Grounds for the appeal

Report of Don A. Hawkins, Architect
February 2, 2004
BZA Appeal 17109

Observations on the Drawings for 1819 Belmont Road, N.W.

SECTION SHOWING REVISED
 PARAPET AND BUILDING
 1819 BELMONT RD., NW 10-14-03
 NORMAN SMITH ARCHITECTURE 202-462-5886
 SCHEMATIC BUILDING SECTION

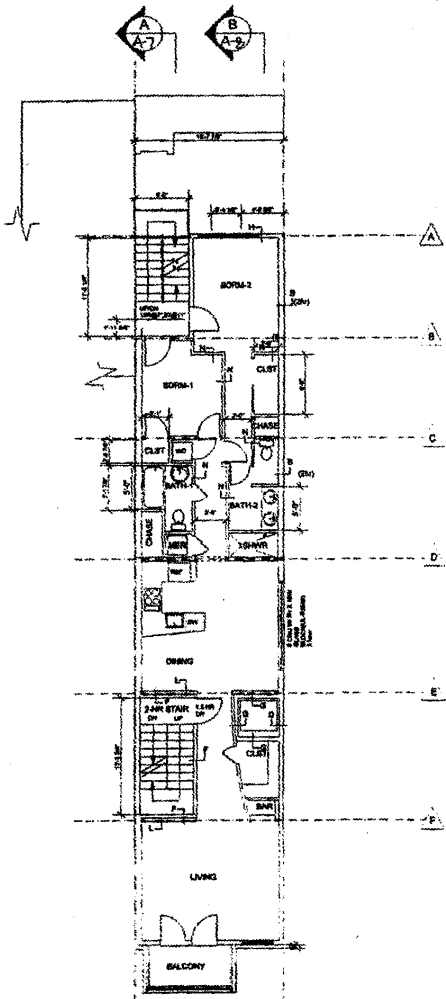
(1) Excessive height. *The plans on the basis of which these permits were issued call for a deck and a banister structure raised above the roof. As a result, the building height will exceed that allowed by the Height Act (DC Official Code §6-601.01 et seq.).*

The revised plans depict a roof deck and balustrade or banister at the front of the building extending by several feet above the roof (see Exhibit 6). These structures are not among the several types of structures and embellishments enumerated in either the Height Act (§6-601.05(h)) or the Zoning Regulations (11 DCMR §§400.3, 400.4, and 400.8) that may be erected on a roof and may, under stated conditions, exceed the allowable building height. Had the legislature intended initially or at any time thereafter to include roof decks and their balustrades in the list of such excepted structures it could have done so. It did not. These structures on the subject property would therefore violate the Height Act and may not be authorized by special exception or otherwise.

Roof Deck and stairway to the roof: The roof deck exceeds the height limit of 70 feet. It does not qualify as a roof structure under the Height of Buildings Act. The stair to the roof is not needed without the deck. **Conclusion:** The roof structure with its stairway should be eliminated, for access to the roof for maintenance purposes could be provided by ladder from the lower roof or a hatch.

Relief sought: The permit for the deck and balustrade should be revoked.

ATTIC PLAN
Scale: 1/8" = 1'-0"

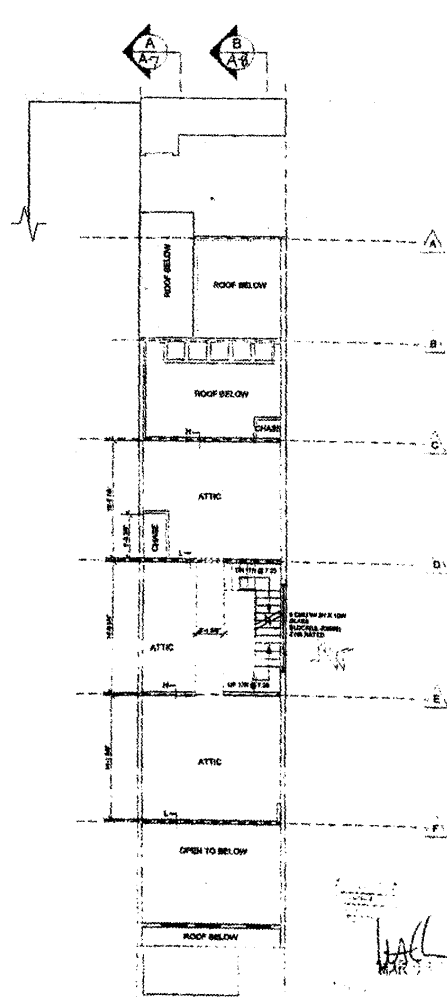
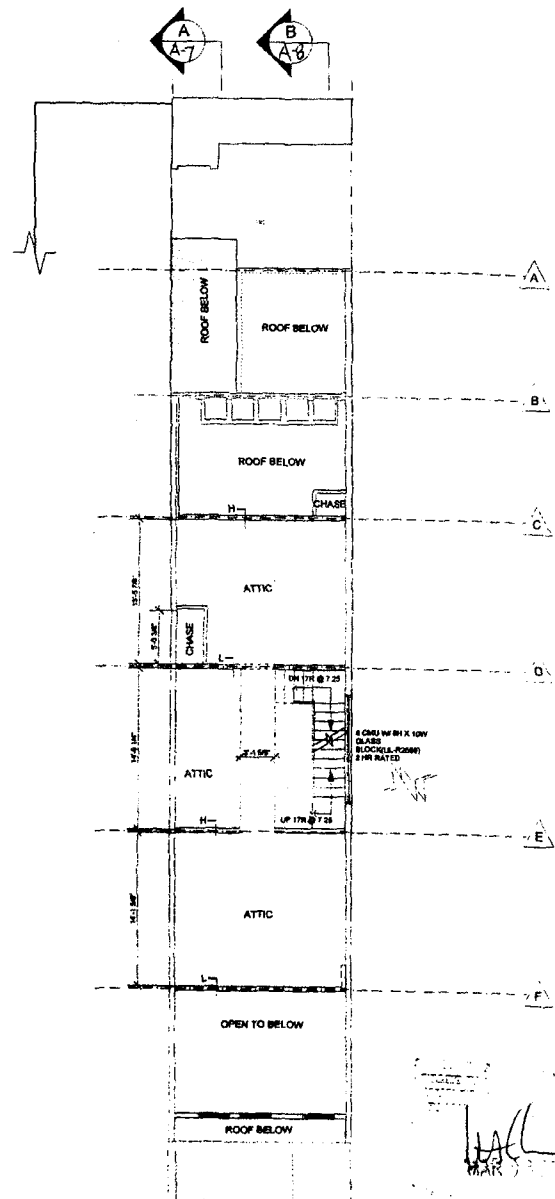
(3) **Excessive F.A.R.** *The portion of the building that the plans label as “attic” is not an attic under either the definition of “attic” contained in the BOCA Code (§1202.1), which we mention because it was invoked by the developers of this project in pre-permit*

Attic: By definition an attic is the space between the top of the ceiling joists of the uppermost story and the bottom of the roof rafters. The only space shown on the Drawings that conforms with the definition of an attic is the small sliver of space less than a foot high at the front of the house.

The ceiling joists are not structurally necessary for the strength or stability of the roof. In the back portion of the "Attic", collar ties are indicated at 4'-0" on center. They are not performing any necessary function and could be removed without weakening the structure in any way.

Not being required, the ceiling joists could easily be removed by a future owner to achieve a higher space and thereby raise the habitable floor area above the allowable.

It might be argued that the ceiling joists, as part of the roof system, are the equivalent of the rafters in the definition, but if the roof is looked at as a system, it must include the mansard roof at the front. The mansard rests on the fifth floor, which would make the fifth floor an attic and the proposed attic redundant. **Conclusion:** The Attic is not an

attic as per definition and appears to be a means of gaining living space. Therefore, its floor area ratio should be counted

Relief sought: The permit for the building should be revoked, and the owner required to apply to the BZA for an F.A.R. variance, without which no certificate of occupancy should be issued.

ROOF DECK PLAN
Scale: 1/8" = 1'-0"

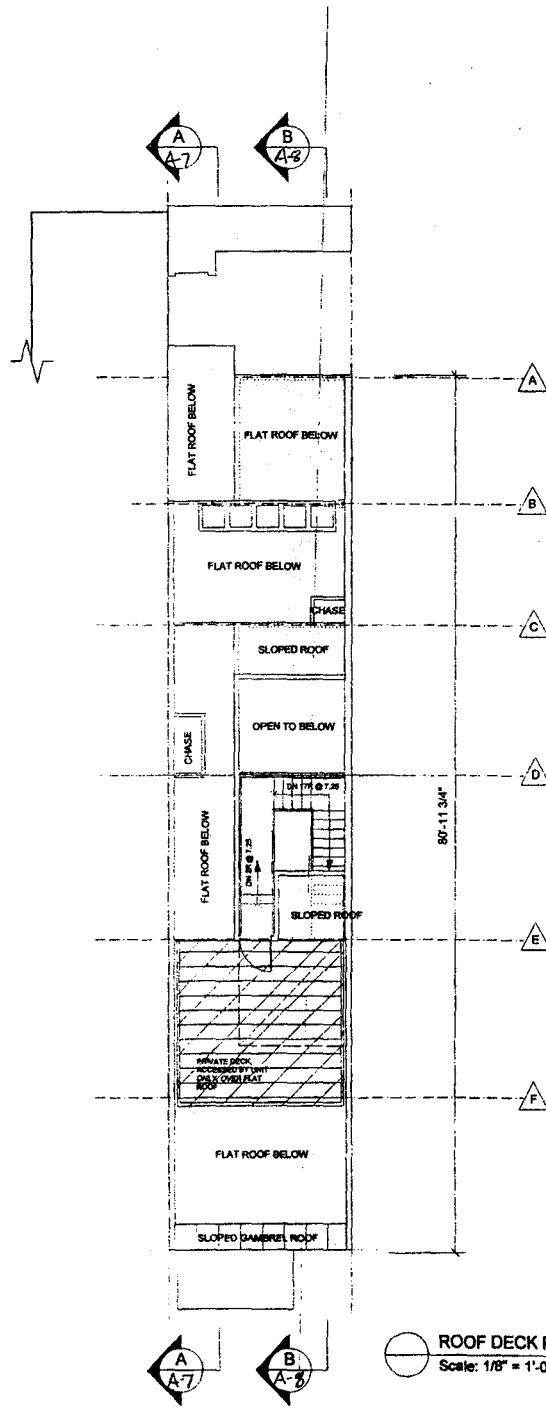
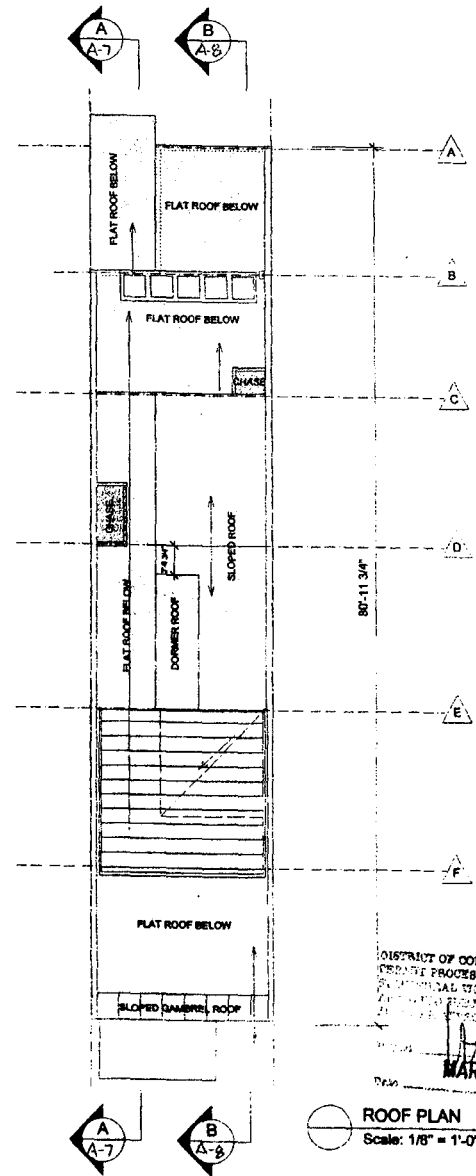
Roof structure: If a roof structure is provided in compliance with the Height Act, it must be set back from all exterior walls by its height. This cannot be done in this instance because of the height of the roof structure, made higher because of its design in relation to the planned raised deck when applied to this narrow row house. It sits on an exterior wall, a party wall on one side. **Conclusion:** The roof structure, especially since it will not be needed without the deck, should be eliminated as not being able to be in compliance, as currently designed, with the Height of Buildings Act.

The permit for the roof structure should be revoked, or the roof structure brought into compliance with the Height Act.

BUILDING SECTION A-A
 Scale: 1" = 10 ft

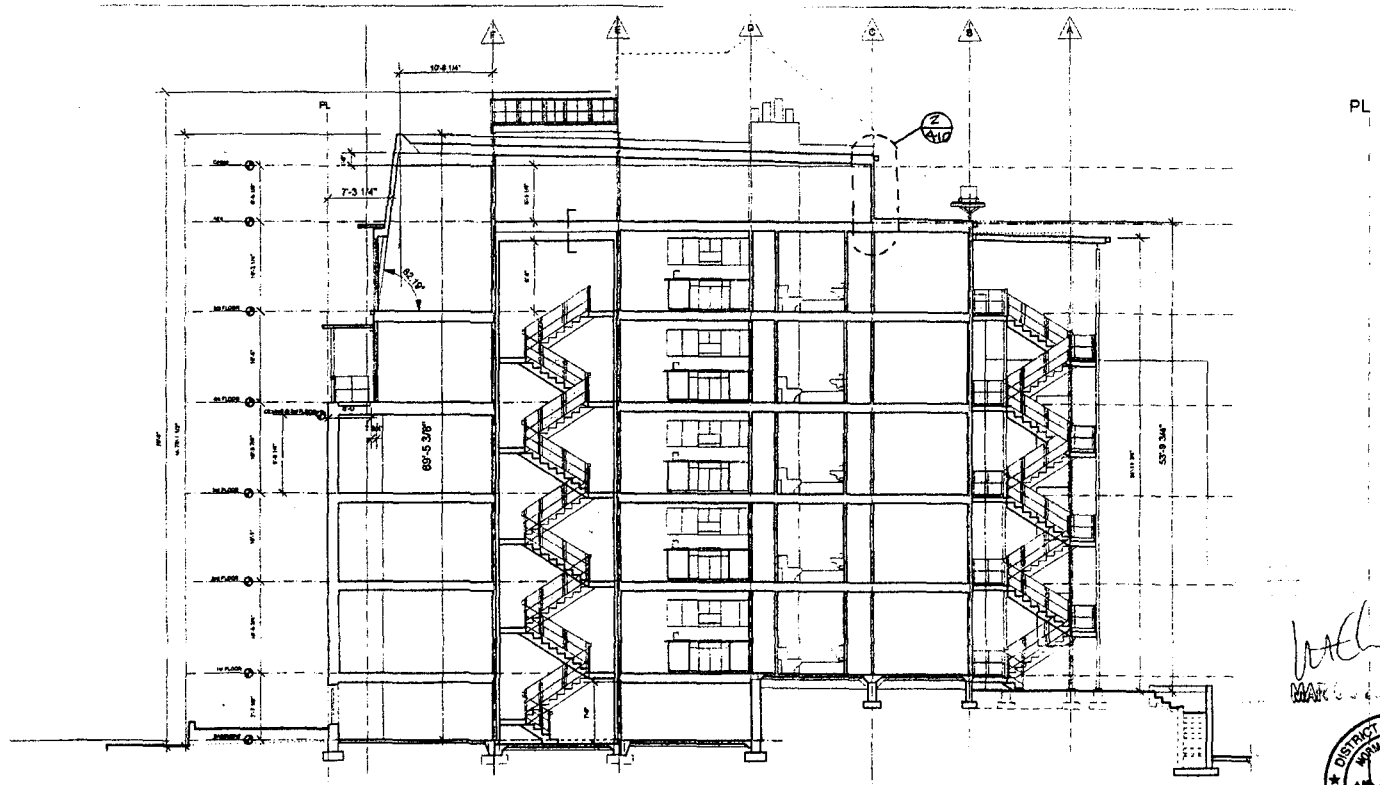
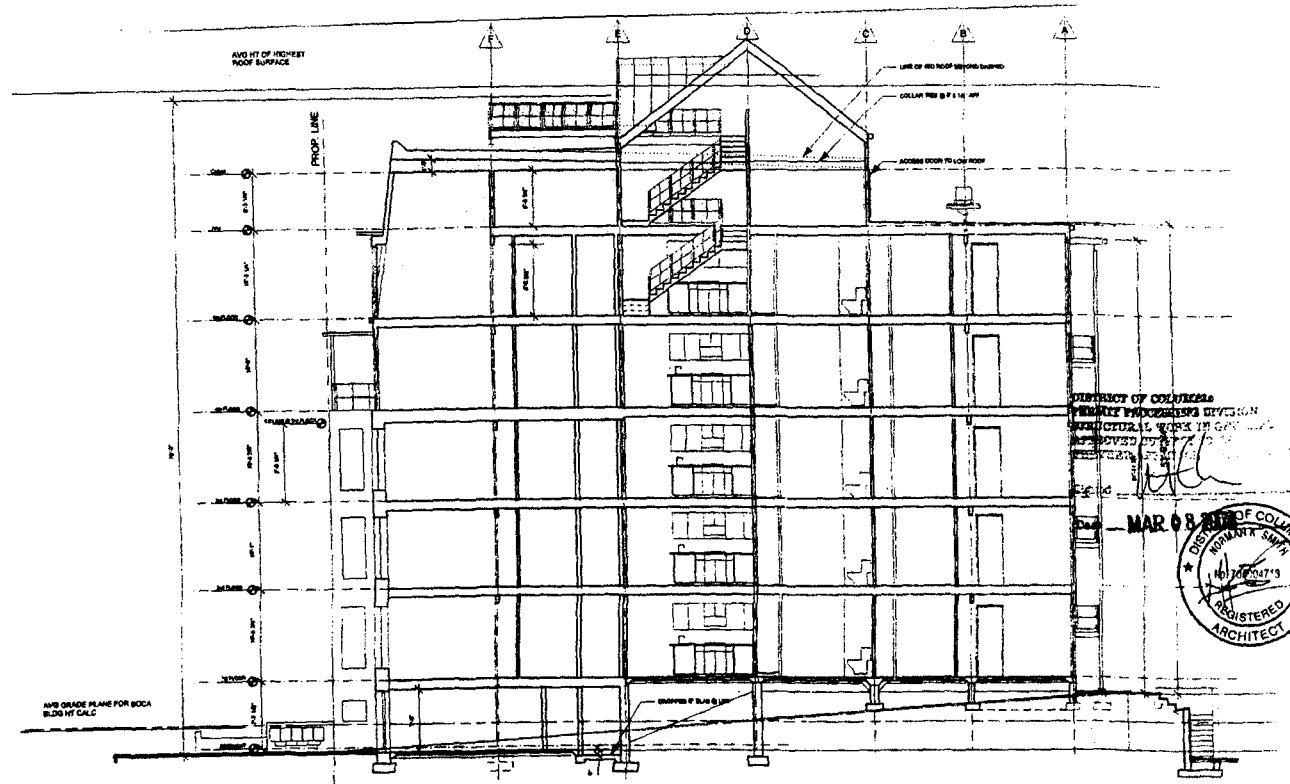
Basement: The earlier set of drawings indicates a height of 7'-7 1/2" from the Basement slab to the First Floor level. The revised set gives a dimension of 8'-2" for the height. I cannot see how that dimension could change, since the grade in front of the building is determined by the height of the public sidewalk, which has not changed. The Basement floor level appears to be at least 6" above front grade. The height of the measuring point of the rear grade above the Basement, calculated with the dimensions given in the Drawings, is 6'-3 1/8". Add 6" for the drop to grade out front, and one finds that the Basement no longer conforms to the Zoning Regulations definition because the floor above it is more than 5 feet above the Grade Plane. **Conclusion:** the entire area formerly called the Basement should be counted in the F.A.R. calculations because its enclosing walls all rise more than four and a half feet above the Grade Plane.

F.A.R. calculations: If the floor area of the Basement is included, as it should be, the F.A.R. increases to 3.78. If the floor area of the attic is included, it increased the F.A.R. to 3.84. If both are included, F.A.R. is increased to 4.13, an excess of 18%. **Conclusion:** the F.A.R. is in excess to the 3.5 F.A.R. allowed in the R-5-D-zone.

The permit for the building should be revoked, and the owner required to apply to the BZA for an F.A.R. variance, without which no certificate of occupancy should be issued.
